## MODEL 124

P91.10-0544-01

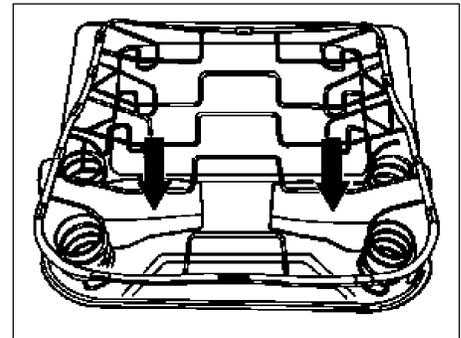
Damage Code	Cause	Remedy	
No Code	<ul style="list-style-type: none"> <li>Insufficient side support of seat cushion frame.</li> <li>With extreme weight on the front seat, the seat cushion cover can be pinched at the front seat tilt adjustment mechanism.</li> </ul>	<p>1 Install two foam block to the seat cushion padding on the left and right side between the two front springs. Part No: 124 910 16 75</p> <p> <b>Production Phase-In:</b> As of 4/89 production.</p>
